Communities Against the Tunnels

Joint Submission to the North South Bypass Tunnel Environmental Impact Statement

April 2005

Figure 1. Variation of particle emission rate with applied power.

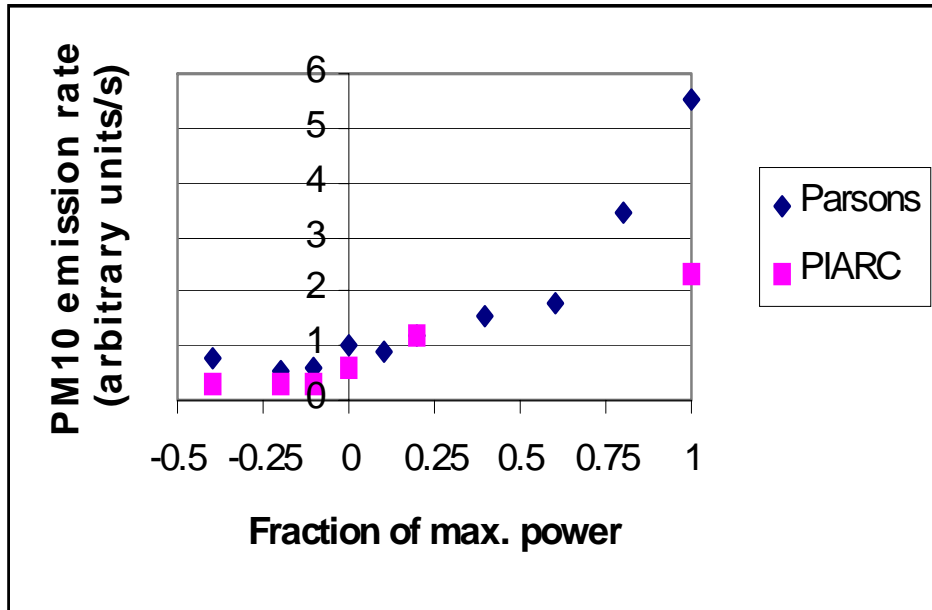
In our view, it is quite possible that actual PM₁₀ emissions could be a factor of two or more higher than the PIARC estimates at full engine load as the majority of the emission will in fact, come from high power operation. It should be re-emphasised that this is new knowledge, not available to Hyder, but in view of the possible potential for exceedence this aspect needs to be taken into consideration.

Figure 2. Effect of heat transfer within a road tunnel. Vent flow = 800 m³/s,

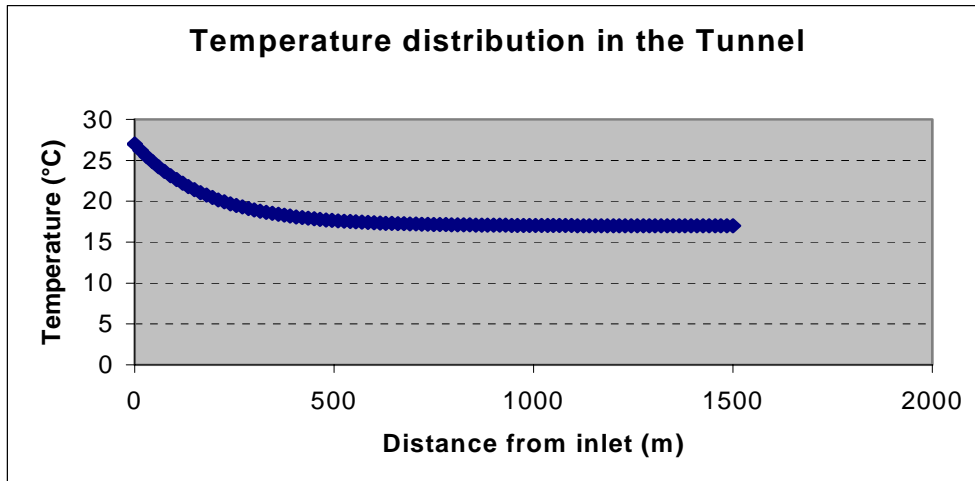
This buoyancy could enhance the effective stack height by 20 m or more. Whilst the reverse will be the case for summer afternoons, the higher dispersion rates, characteristic of neutral to unstable conditions at these times, means that the impact of negative buoyancy will be much less and also closer to the predictions of plume behaviour presented in the Hyder Reports.

As the degree of thermal buoyancy is proportional to the volume flow rate for a given temperature difference, it becomes quite small at the lowest fan speeds projected for minimum traffic flow so that there may well be only a small benefit for overnight plume strike conditions throughout the year.

Figure 6 Contour map of the maximum dispersion ratios based on measurements (at the sites indicated by dots) in the physical modelling of neutral flow conditions for the 35 m stack.

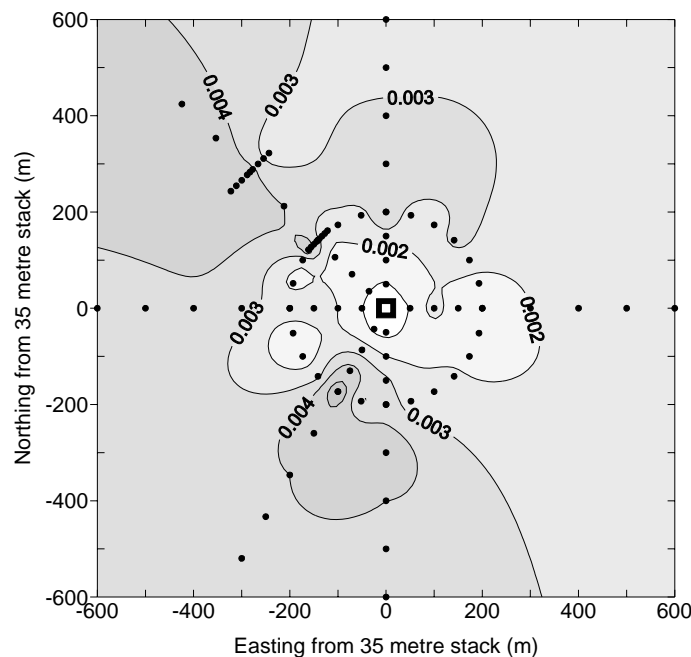
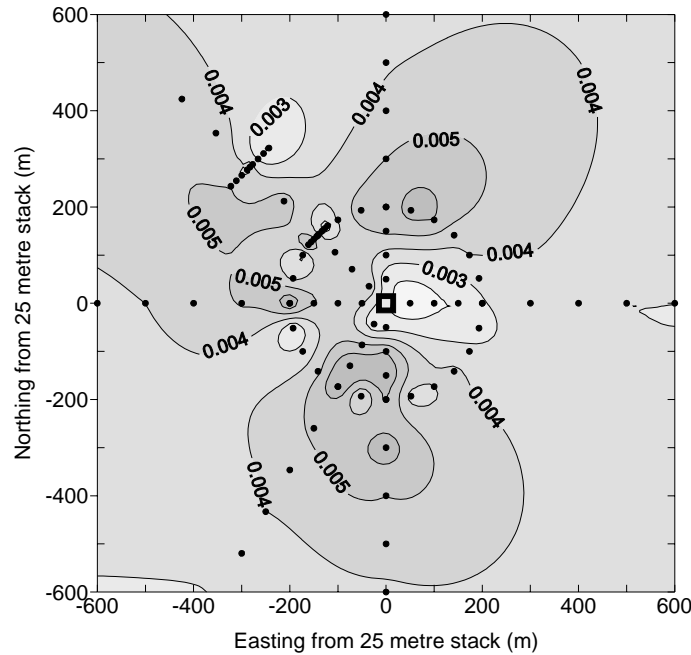
The overall quality of the presentation of the physical modelling results in the Hyder Reports is poor. There are over 200 pages of Figures in each Report showing results from each of the individual tests, but almost no summary plots other than Figure 8. In order to interpret the physical modelling results, contour plots of maximum dispersion ratios (Figures 6 and 7) have been extracted to determine the internal consistency and the influence of the topography. At each location, the maximum dispersion ratio has been extracted from the Figures in the Reports. Note that the contouring has been done to assist in visualising the results and no significance should be given to contour lines in regions where there are no data.

Both contour plots (Figures 6 and 7) show good internal consistency between the data measured in the various series for each stack, although the data for the 25 m stack appear to be slightly noisier. In both cases, the maximum dispersion ratios are observed 200–300 m downwind from the stack, possibly slightly further downwind for the higher stack. The peaks tend to occur on the hills to the north and south, as indicated by the topographic contours shown in Figure 5.

Figure 8. Comparison of maximum dispersion ratios for neutral and stable flow conditions as measured in the physical modelling for a southerly wind.

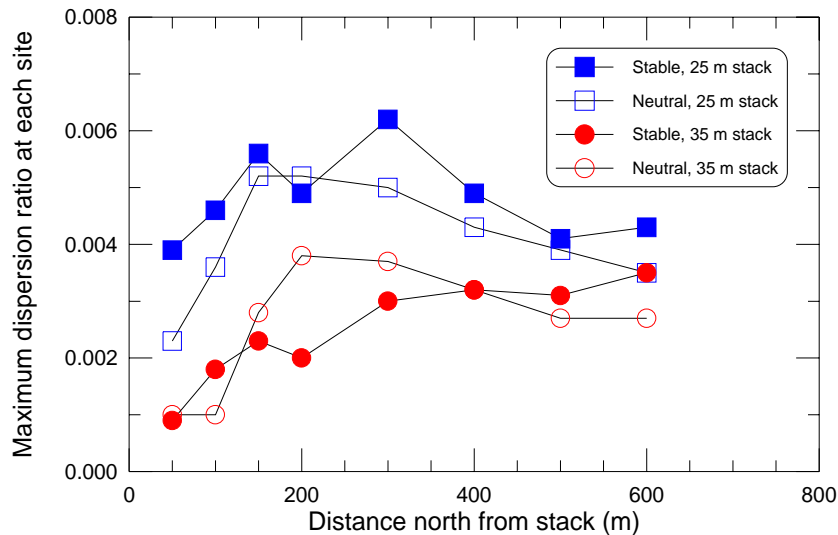
For the wind speeds and stack efflux velocities producing the highest dispersion ratios, the physical modelling showed remarkably little change in the maximum dispersion ratios at ground level when the flow conditions were changed from neutral to stable, as shown by our analysis presented in Figure 8. This is all the more surprising because the stability of 0.077 K m^{-1} used in the physical modelling is twice as large as that assumed in the corresponding mathematical modelling. This lack of influence of stability was not commented on in the report, although it has been explained in later communication with Hyder as being due to high low-level turbulence in the high wind speed conditions. It should be noted that at lower wind speeds and higher efflux velocities, the modelling results do show significantly lower glcs in stable conditions.

Some doubt about the reliability of the wind tunnel measurements in stable conditions is indicated by our analysis presented in Figure 9, which compares the vertical profiles measured 400 m downwind from the stack in neutral and stable conditions at the same efflux velocity and wind speed. Although the plume is not mixed to the ground as effectively in stable conditions, the figure shows that more of the plume is transported to higher levels in the stable case than in the neutral case. For the stack height of 35 m, the plume released into the stable environment is distributed more evenly between elevations of 25 m and 125 m, and the concentration at 125 m is more than five times greater than in the neutral case. This is counter to our expectation that stable conditions should inhibit vertical transport of the plume.

Figure 9. Comparison of vertical concentration profiles for neutral and stable flow conditions at sites 400 m downwind from the stack. The neutral profile was measured NW from the stack, and the stable profile due north of the stack.

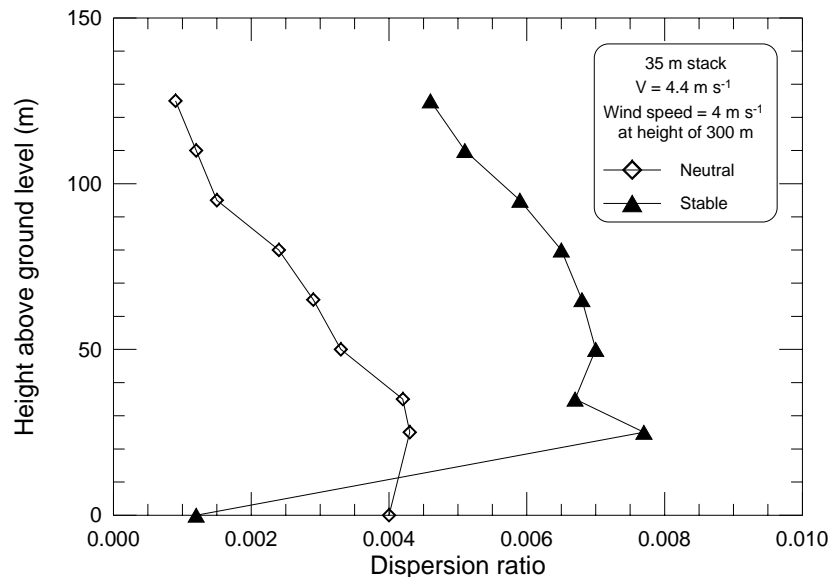
Moreover, a simple pollutant flux estimate using the concentration profiles in Figure 9 and assuming a power law velocity profile shows more than twice as much pollutant flux in the stable case as in the neutral case. The shapes of the upper parts of the concentration profiles also suggest that this difference would be greater if measurements had been made to higher elevations. If both profiles are on the plume centreline, there would need to be considerably more horizontal dispersion in the neutral case (against expectations) in order to match the pollutant fluxes in the two cases. This surprising result suggests a lack of consistency between the emissions for the two cases.

We conclude that the physical modelling for neutral flow conditions is close to reality for the modelled conditions. However, the lack of data for wind speeds below 4 m s^{-1} (equivalent to 2.7 m s^{-1} at 10 m above ground level) is a significant limitation of the physical modelling. In particular, it makes it impossible to compare the physical modelling with the mathematical modelling at the wind speeds as low as 1 m s^{-1} , which existed at the times of the highest glcs predicted by the mathematical modelling.

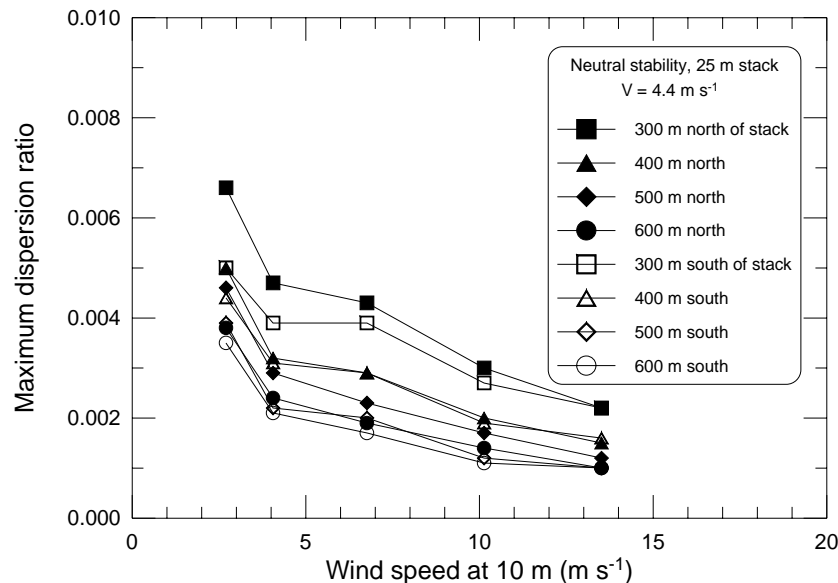
We conclude that with the data provided in the Hyder Reports it is impossible to make a valid comparison between the physical and mathematical modelling. This is in part because of the absence of physical modelling at wind speeds below 2.7 m s^{-1} for neutral conditions, and also because of the problems with the physical modelling of stable conditions. However, if the wind speeds, directions and stability classes corresponding to the maximum dispersion ratios for each efflux velocity (Table 4.1 of Part 3 of the Hyder Reports) were available, it may be possible to make a comparison for conditions for which both physical and mathematical modelling results were obtained. At present it is not possible to appeal to the physical modelling to prove that the numerical model predictions are conservative estimates of real-world conditions with the M5 East stack operating.

most likely that higher dispersion ratios occur at lower wind speeds. (Data from the physical modelling, Figures 18, 20, 22, 24, 50, 52, 54, and 56 of the Hyder Report for 25 m stack.)

Figure 11. Contour map of the ratio of maximum dispersion ratios for the 35 m and 25 m stacks for neutral flow conditions as determined by the physical modelling.

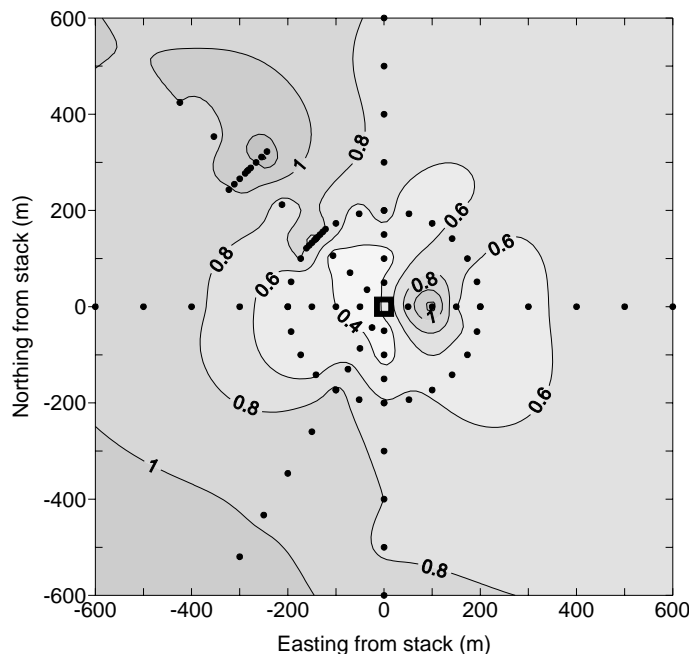
The effect of changing the stack height on the maximum dispersion ratios is shown in Figure 11 for the physical modelling. The Figure plots the ratio of results from the modelled 35 m stack to the modelled 25 m stack. Increasing the stack height from 25 m to 35 m generally reduces the concentrations by about 50% within 200 m of the stack (the exception 100 m east of the stack is probably due to an unfavourable combination of errors). The locations with slightly larger dispersion ratios (400 m NW and 600 m SW of the stack) correspond to elevated regions, and probably reflect an increase in plume impact. Note that these results are for neutral stability.

We conclude that with the stack exit conditions listed in the main Hyder Reports (2000a, b), the higher stack height (35 m) would be advantageous, especially given that conservative methods of including background NO₂ (hour-by-hour addition is not necessarily conservative), would increase the total NO₂ closer towards the air quality goals.

Figure 12. Sensitivity test of final plume height to stack exit velocity for the 35 m stack.

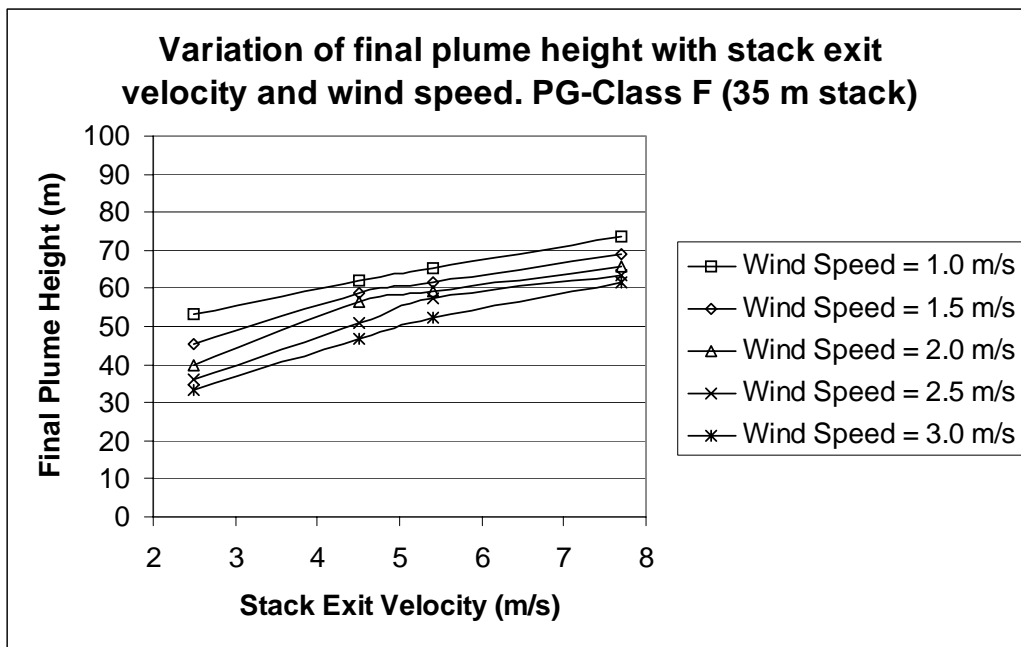
If stack exit velocity was increased for hours 21, 22 and 23 (currently 5.4, 4.5, 2.5 m s⁻¹ respectively), then ten (nine) of the top ten listed maximum stack concentrations, listed in the Hyder Report for a 25 m (35 m) stack, would decrease due to an increase in the effective plume height (see Figure 12). Note that stack-tip downwash is important when the ratio of the exit velocity to the wind speed at stack height becomes less than a ratio of 1.5, and this is predicted to be having a significant effect on maximum stack concentrations, particularly at hours 21–23.

The effect on maximum NO₂ ground level concentration of increasing stack exit velocity for hours 21 and 23 has been explored in the Hyder report (2000d) on air quality modelling for incident management. It was shown that by increasing the stack exit velocity from 5.4 m s⁻¹ to 9.0 m s⁻¹, the ground level concentration due to the 25 m stack for hour 21 on 29/10/95 was decreased from 169.1 to 111.6 µg m⁻³. When using the conservative maximum monthly background approach, this results in a cumulative concentration of 225 µg m⁻³. It was also shown that by increasing the stack exit velocity from 2.5 m s⁻¹ to 4.5 m s⁻¹, the ground level concentration due to the 25 m stack for hour 23 on 08/10/95 was decreased from 164.1 to 110.5 µg m⁻³. When using the conservative maximum monthly background approach, this results in a cumulative concentration of 224 µg m⁻³. These results illustrate that simply by increasing the stack exit velocity for certain night-time hours (e.g. hours 20-23), the air quality goals for NO₂ can be achieved, even for the 25 m stack, and when using a conservative approach to include background NO₂ concentrations.
